Date: September 5th, 2022

To: Dan Osoba, Planner II
City of Aurora Planning Department

This document is a response to the Harmony SP5 second submission review comments we received on July 14, 2022.

Application Number: DA-1925-11

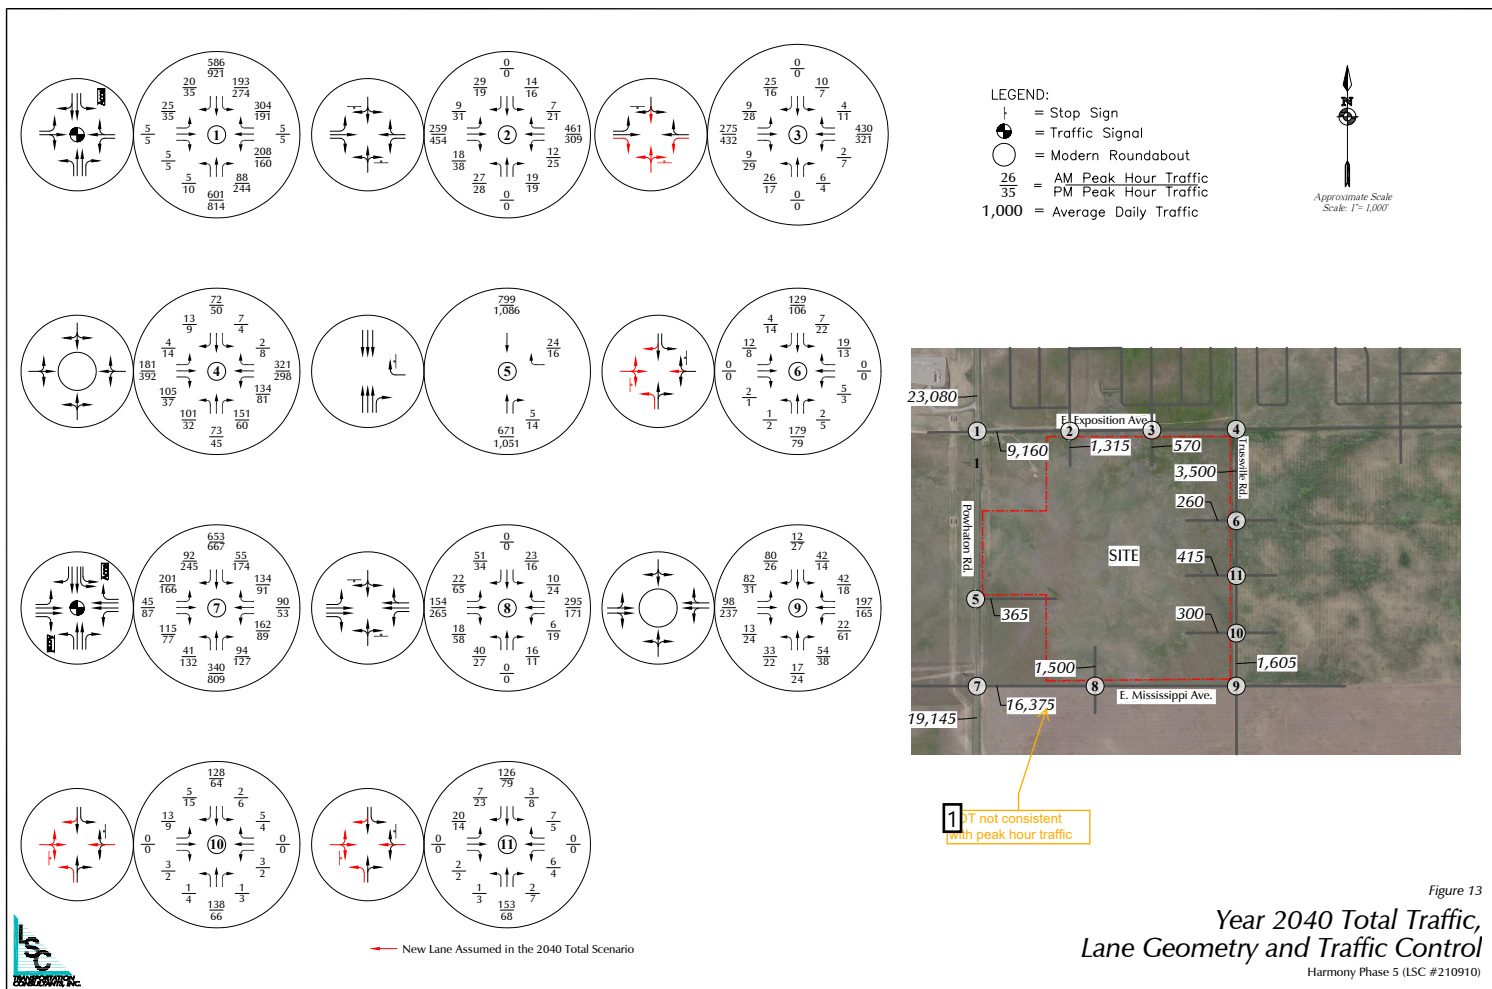
Number: 1 Author: segomez Subject: Callout Date: 7/5/2022 1:17:15 PM
ADT not consistent with peak hour traffic

LSC Response: The additional graphic has been added as requested
